SUBJECT: NuScale Power, LLC Supplemental Response to NRC Request for Additional Information No. 9466 (eRAI No. 9466) on the NuScale Topical Report, "Non-Loss of Coolant Accident Analysis Methodology," TR-0516-49416, Revision 1

NuScale Supplemental Response to NRC Request for Additional Information eRAI No. 9466

eRAI No.: 9466

NRC Question No.: 15.00.02-7

[Figure 7-1](#) Example of decay heat comparisons

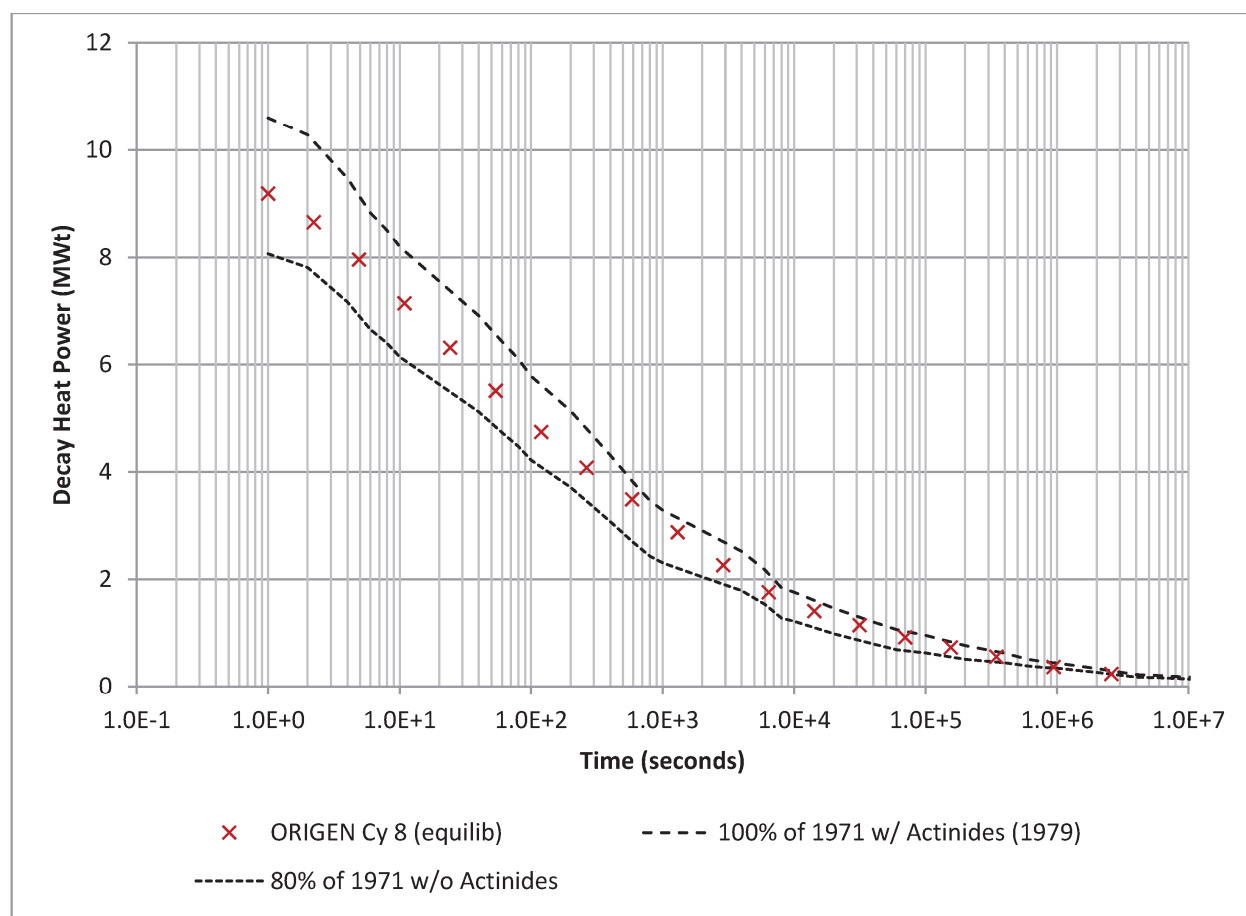
According to TR Section 7.1.5.3, decay heat is biased either low or high, depending on the transient being analyzed, by use of decay heat multipliers and specifying whether or not to include the actinide contribution. The staff requires justification that, as altered by multipliers and actinide contribution in the non-LOCA analyses, the 1973 model leads to conservative results. In response to an audit discussion (Round 2, Issue 5), the applicant stated in the quality assurance process for NRELAP5, some of the decay heat models were subjected to greater scrutiny, with the 1973 decay heat model being one of greater pedigree. Therefore, it was selected for use. The applicant stated that a calculation that examined the various decay heat models was performed, and the results helped determine that a multiplier for a maximum or minimum decay heat level was appropriate.

Because decay heat affects energy production in the core and therefore transient progression, the staff requires additional information about the use of the 1973 decay heat model and the methodology for selecting the values used for λ and η .

Provide the actual values of λ and η used and references for these parameters, and justify that the use of these values, the specified multipliers, and inclusion (or lack thereof) of actinides in combination with the 1973 decay heat model leads to a conservative result for decay heat contribution for all event types. Update TR-0516-49416-P and any other affected documentation as appropriate.

A best estimate decay heat curve was generated using the ORIGEN code for a generic equilibrium cycle. A sample figure which includes the minimum and maximum decay heat curves bounding the best estimate curve was added to the topical report Non-Loss of Coolant Accident Analysis Methodology, TR-0516-49416, as shown at the end of this response. The

The following decay heat contribution values are examples for the NPM. [Figure 7-1 provides an example of the decay heat as a function of time for an equilibrium cycle.](#) A review of the applicable core physics parameters is performed each cycle to confirm the bounding nature of the values utilized for the non-LOCA transient analyses.

- Low = use multiplier of 0.8 while excluding the actinide contribution
- High = use multiplier of 1.0 while including the actinide contribution
